MILITARY SPECIFICATION

MICROCIRCUITS, DIGITAL, ADVANCED LOW-POWER SCHOTTKY TTL, DECODERS,

MONOLITHIC SILICON

This amendment forms a part of Military Specification MIL-M-38510/377(USAF), dated 9 August 1983, and is approved for use by the Department of the Air Force and is available for use by all Departments and Agencies of the Department of Defense.

Device type 01
Case 2

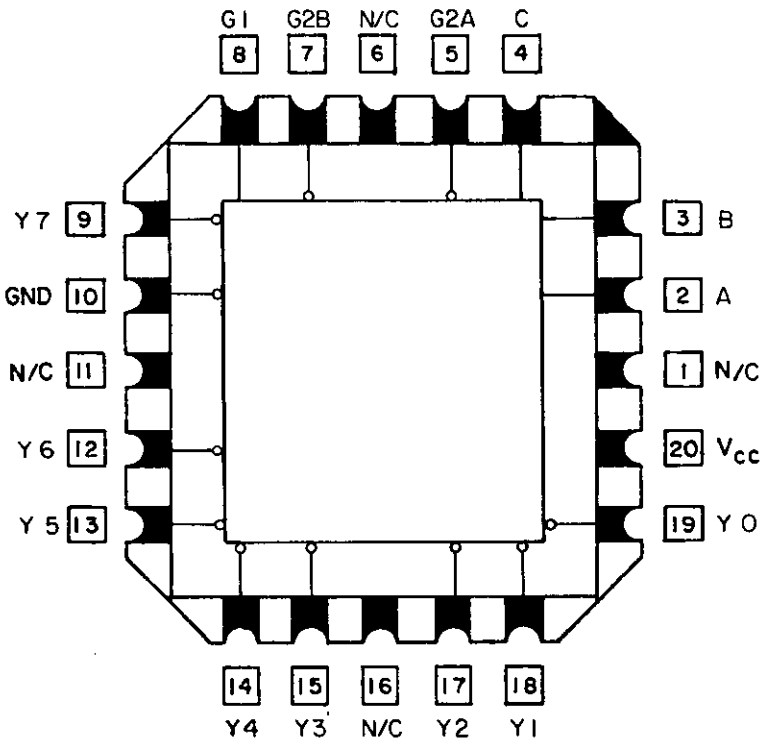
FIGURE 1, Device type 01, Case X: Delete "Case X" and substitute "Case 2".

FIGURE 1, Device type 01, Case 2, delete and substitute the following:

FIGURE 2. Logic diagram and truth table.

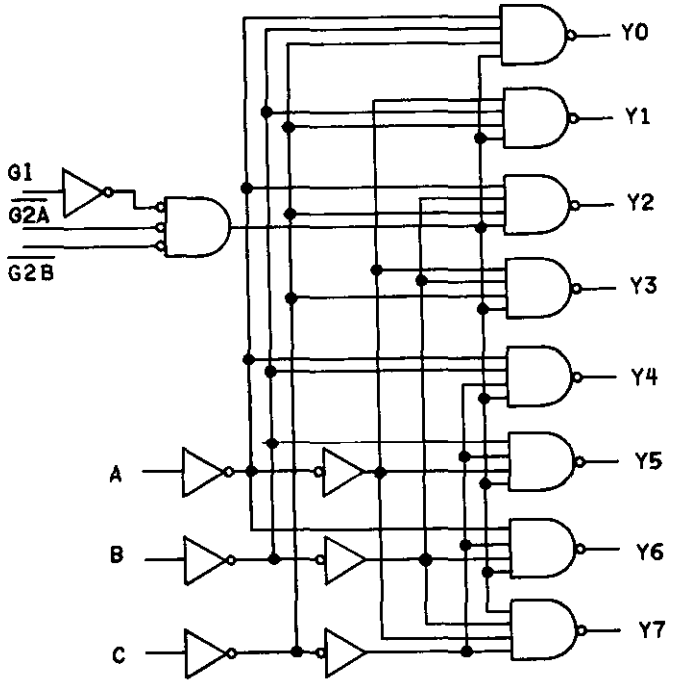
FIGURE 2: Delete and substitute new figure 2 as printed on page 4 of this amendment.
